**RE: Response to Request for Additional Information**

Project Name: Riopelle-Ariana Farms - Rezoning

Application No.: H-25-26

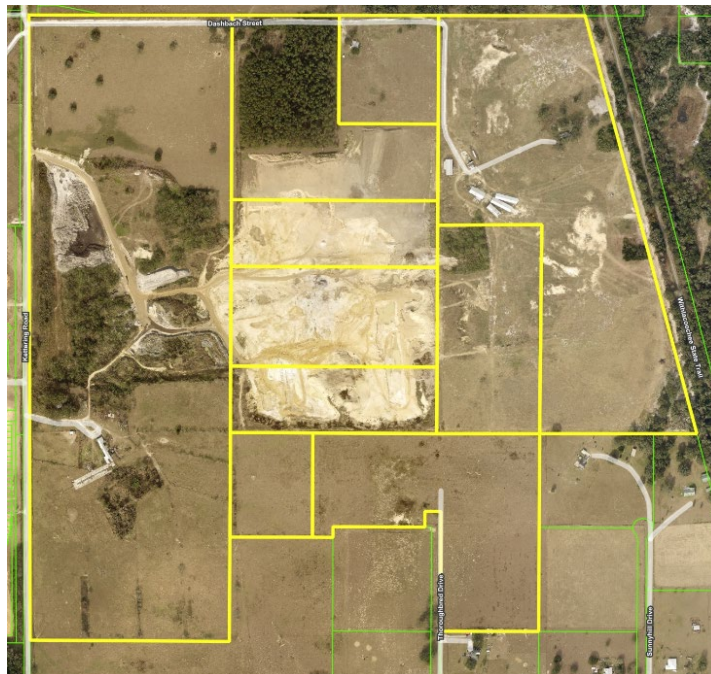
Pedestrian connectivity is needed to connect the various pods.

***Response: See Aerial Image below. The property lacks existing vegetation; a natural vegetative buffer will not be possible in this location. All Buffers will be landscaped with the exception of the East Property line adjacent to the Withlacoochee State Trail. See Buffer Type 3 for proposed cross section. A Fence is not required but can be installed at the Developers' discretion.***

***Response: Confirmed. Pedestrian Connectivity will be met through internal sidewalks. All internal Sidewalks will connect to the Park/Amenity Areas. An optional pedestrian connection to the***

***Withlacoochee State Trail to the east has also been added to the Master Plan within the Park/Amenity Area that connects to the eastern boundary.***
